Change of socket material and integration of V-Lock cord retaining feature as standard.

Product Change Notification						C20F snap-in and screw-on rear version PCN	
owner	creation date	release date	released by	change order no	rev	page	D10-015-728
sariogar	09.05.2017	30.10.2017	blumhe	2010167	A	1 of 2

Old product appearance	New product appearance
<p>Snap-in mounting from front side</p> 	<p>Snap-in mounting from front side</p> 
<p>Screw-on mounting from rear side</p> 	<p>Screw-on mounting from rear side</p>

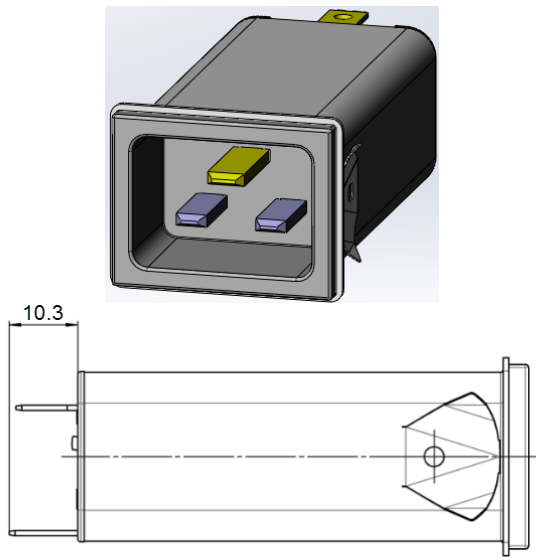
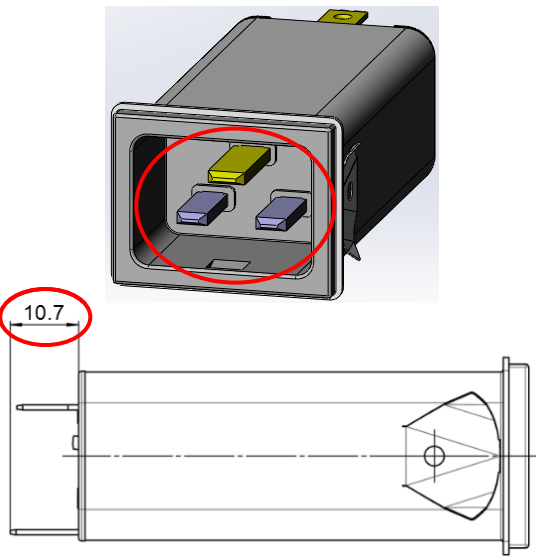
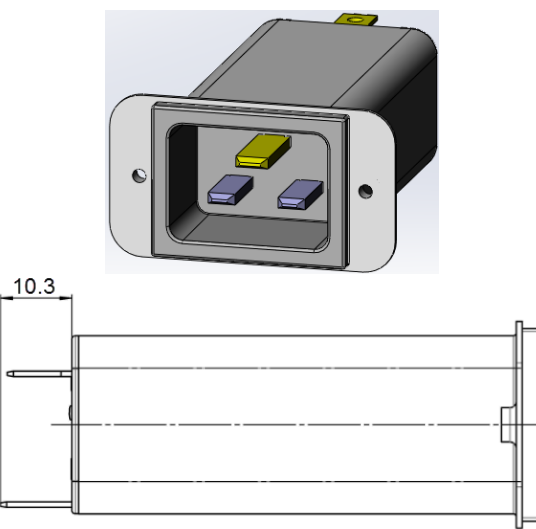
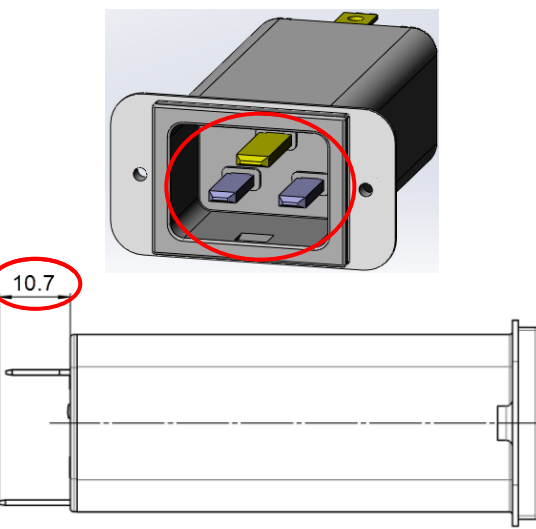
- Socket material change from PA6 to PA66/6 to pass the enhanced requirements of glow wire test acc. to IEC 60695-2-12 and -13
- V-Lock cord retaining integrated as standard feature (not an option anymore)

Form	Yes	Socket has notch for V-Lock cord retaining, new form on extended socket dimension and socket base.
Fit	Yes	Installation depth is 0.40 mm extended.
Function	Yes	V-Lock feature is standard (not an option anymore)
Production Site	No	There is no change of the production site
Product Label	No	No label change
Customer Action	Yes	PE-Terminal is 0.4mm longer. Check installation depth in the application. Change SCHURTER part number if affected.

As the V-Lock notch and material for enhanced glow wire tests will be standard features, the material numbers with index .21 are obsolete and will be replaced by the standard numbers:

C20F.0112.21 ⇨ C20F.0112      C20F.0224.21 ⇨ C20F.0224  
C20F.0222.21 ⇨ C20F.0222
